New Bedford  
5.4  
SDMS 293980

DECLARATION FOR THE EXPLANATION OF  
SIGNIFICANT DIFFERENCES

New Bedford Harbor Site/Hot Spot Operable Unit  
New Bedford, Massachusetts

**EXPLANATION OF SIGNIFICANT DIFFERENCES  
NEW BEDFORD HARBOR SITE/HOT SPOT OPERABLE UNIT  
NEW BEDFORD, MASSACHUSETTS**

FIGURE 2  
CONCEPTUAL CDF COVER DESIGN

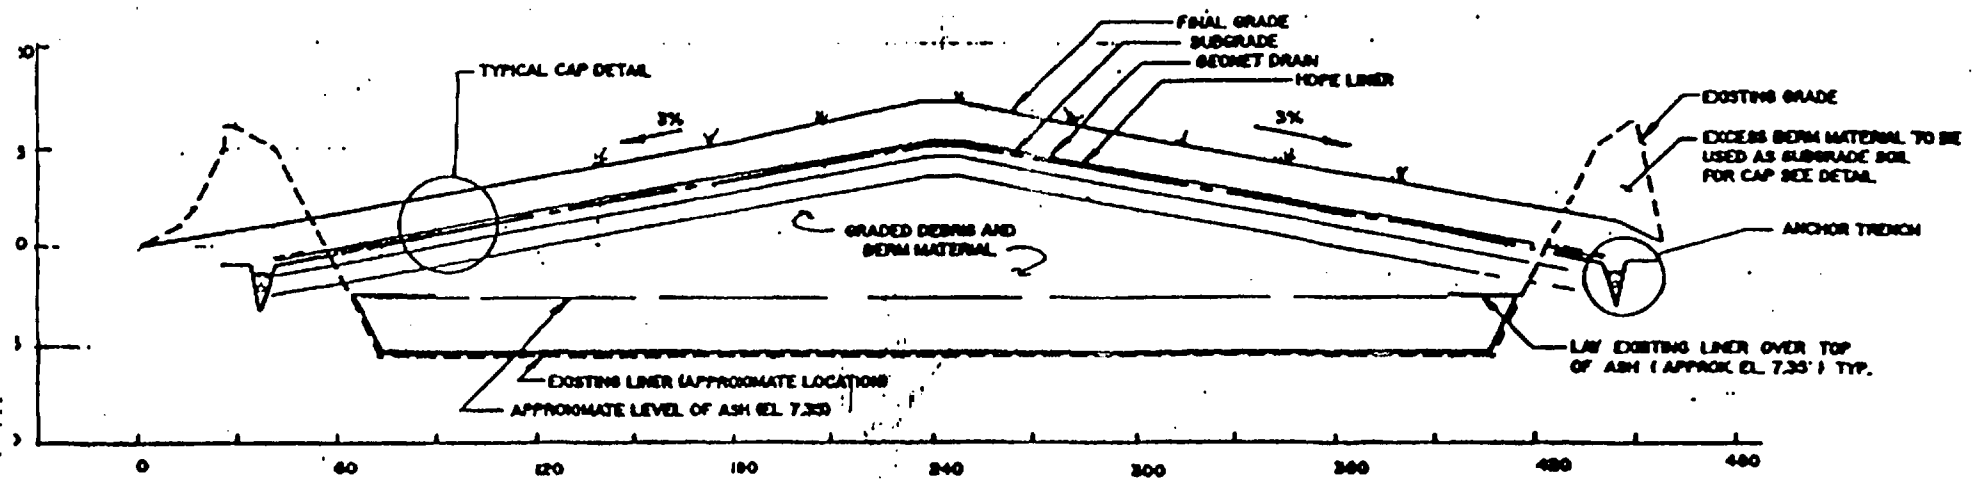
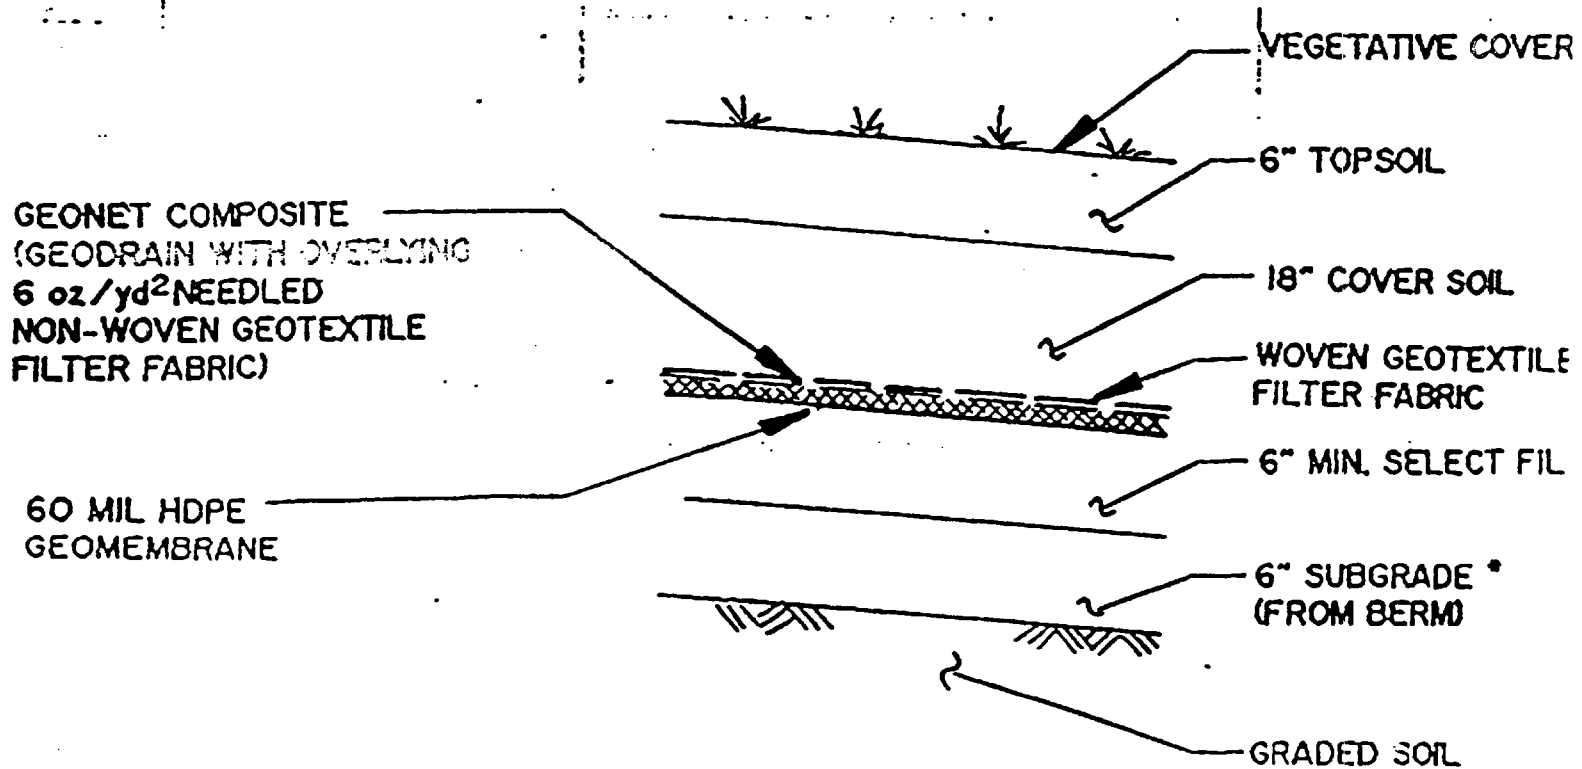
The cover for the CDF is being designed to attain the final cover closure requirements for hazardous waste landfills (310 CMR 30.633). The cover system will include a bedding layer, an impermeable flexible membrane liner (with a drainage layer) and finally, a two-foot-thick soil/vegetative cover layer. See Figures 2 and 3 for conceptual design drawings.
